PB-MGE05-05 US

### Product Bulletin – Aluminum Structural Framing

## Updates and Corrections to the MGE Catalog v.4.0

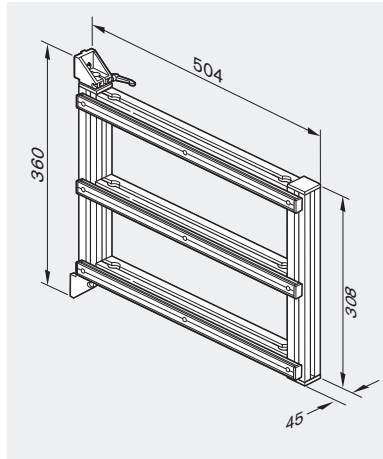
**Page 11-12:** Please change the bin wing height dimension from 215 to 360, as shown.

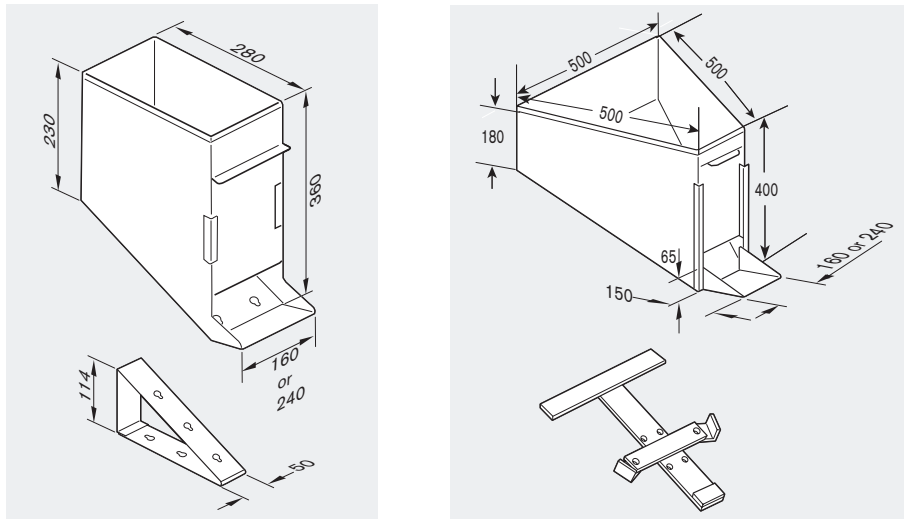
**Page 11-19:** Reference dimensions have been added to the silo drawings as shown.
